## DESCRIPTIVE REPORT

Type of Survey ..... Hydrographic  
Field No. .... RA-10-5-98  
Registry No. .... H-10806

State ..... Alaska  
General Locality ..... Lynn Canal  
Sublocality ..... Taiya Inlet

# EVALUATION REPORT

ATTACHMENT 1  
 H-10806 (AdWk) LIMITS DEPICTED ON CHART  
 17317, 18th EDITION, JUNE, 14, 1997  
 LIMIT LINE DENOTES AREA OF SUPERSESSION  
 Superseded Area Of Chart 17317

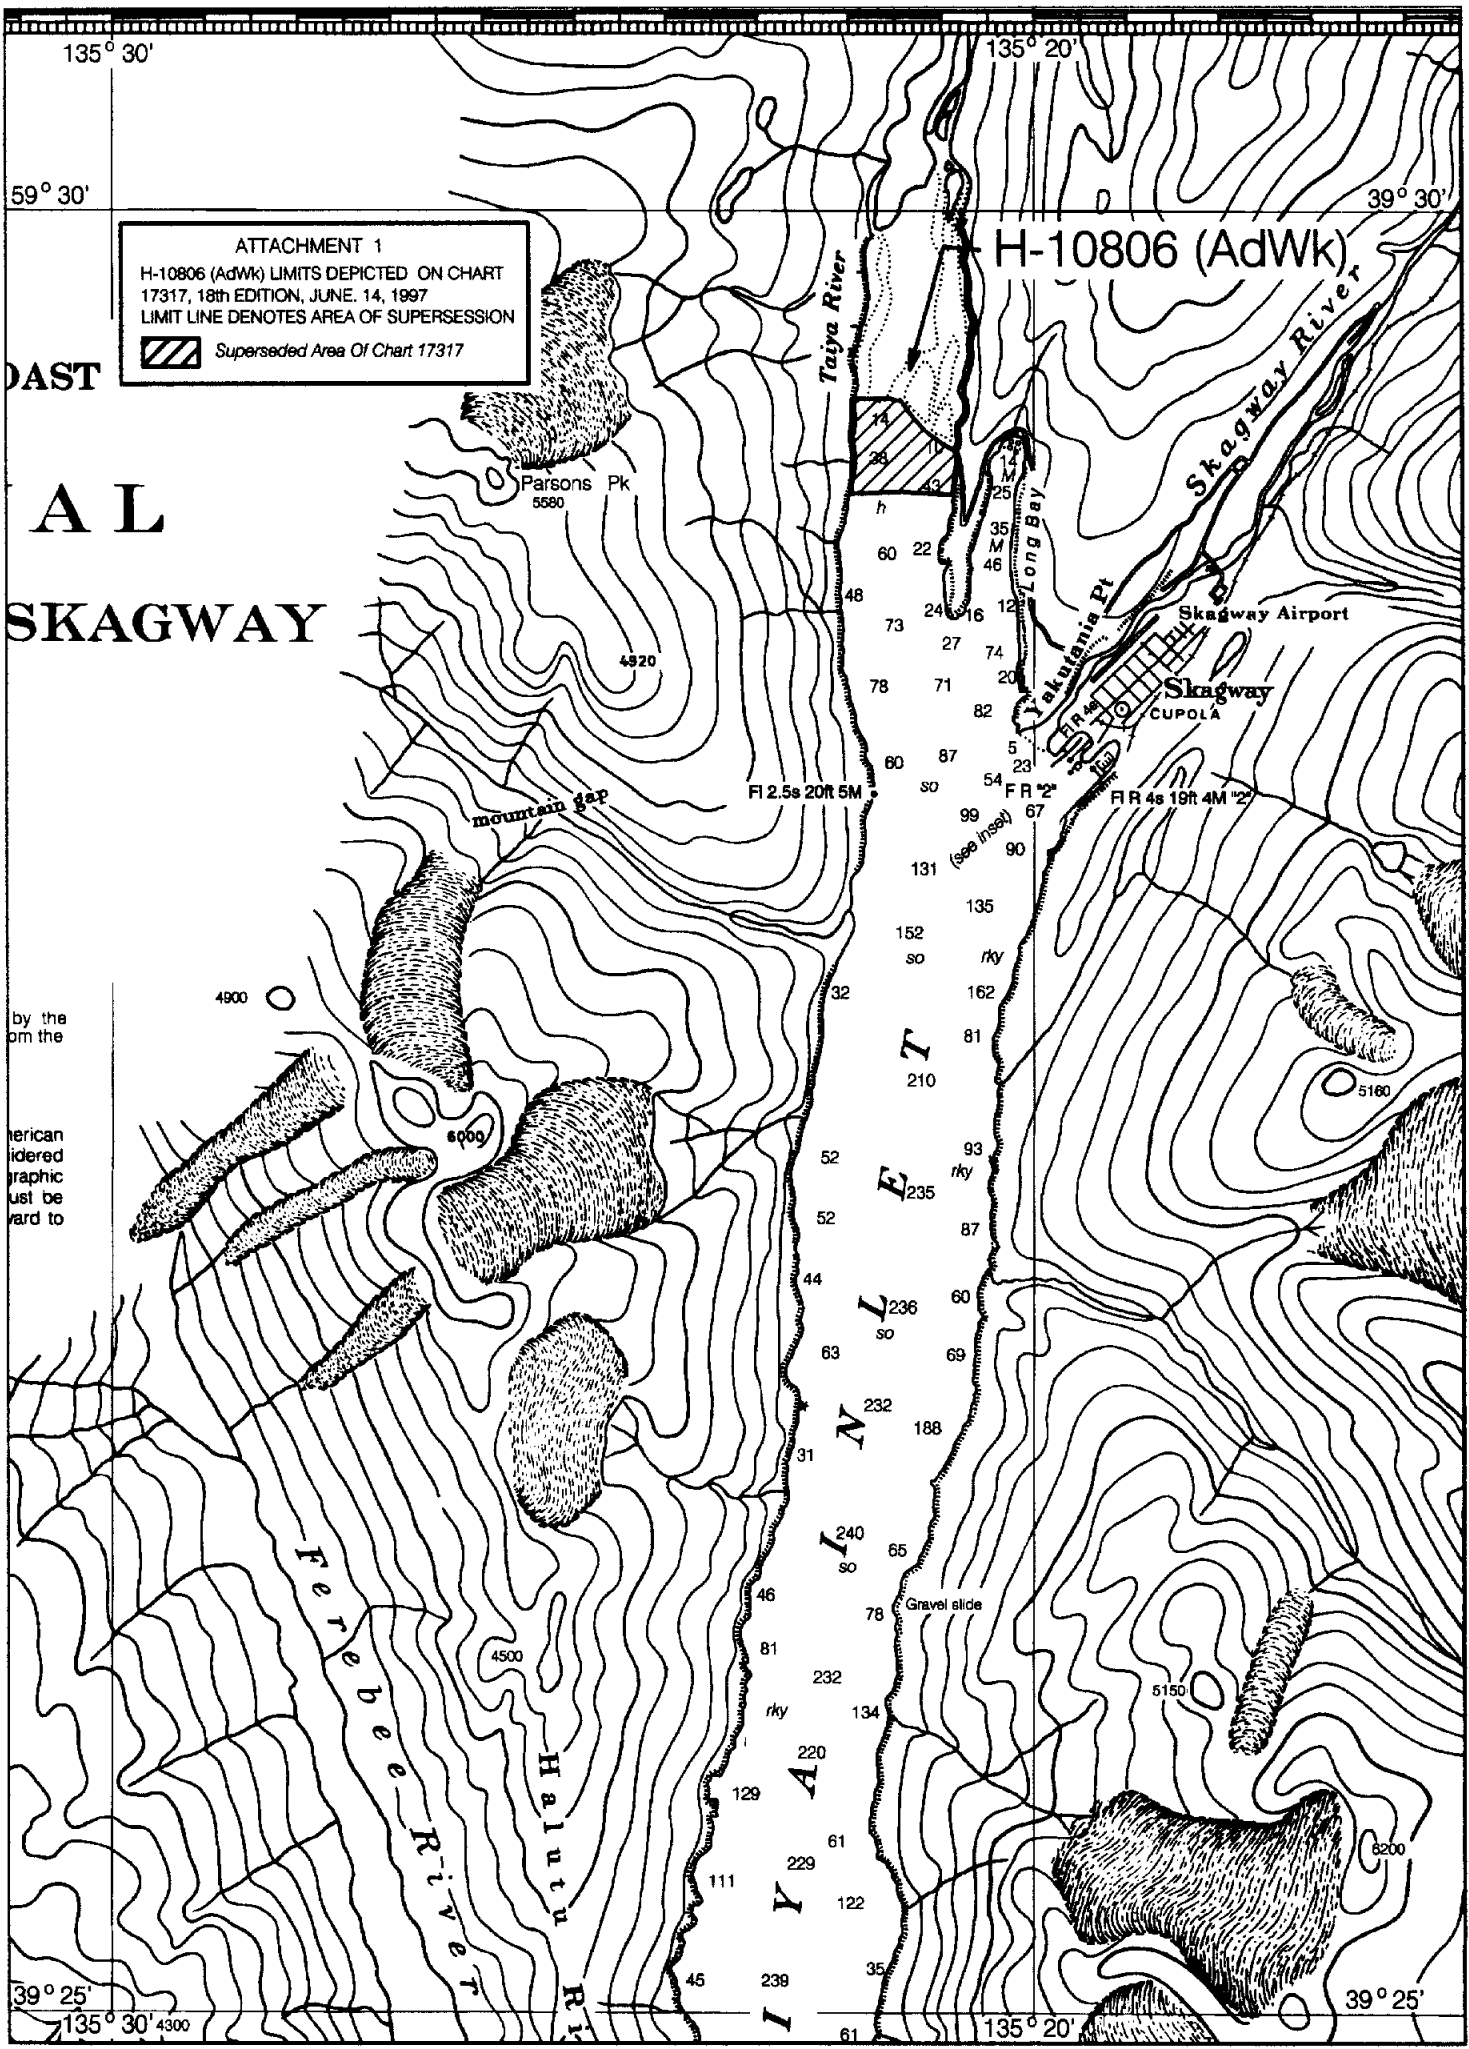
The hydrographer has determined the inshore limits of safe navigation by defining a Navigable Area Limit Line (NALL) throughout the survey. Charted features and soundings inshore of this limit line which have not been specifically addressed during survey operations should be retained as charted. Page-size plots of the charted area depicting the specific limits of supersession accompanies this report as Attachment A and B.
